Case File / Name: S-46-14 / Chestnut Hills Lot 59

Nature of Case: Subdivision of a 0.52 acre parcel zoned Residential-4 into two single family lots.

OFFICIAL ACTION:

Approval with conditions

Subdivision Layout

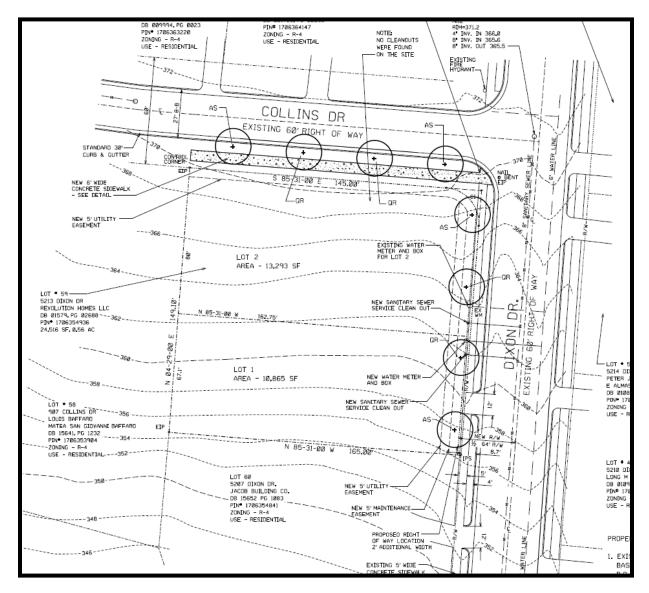
- (1) That a fee-in-lieu of construction be provided for the additional 1' of required sidewalk along Dixon Drive;
- (2) That a demolition permit be issued and this building permit number be shown on all maps for recording;
- (3) That ½-64' right-of-way dedication, 5' utility placement easement, and a 5' street tree maintenance easement be dedicated to the City of Raleigh as shown on the preliminary plan and be shown on all maps for recording.

(4) That a planting detail for the streetscape trees is approved in accordance with the standards set forth in the Raleigh Street Design Manual;
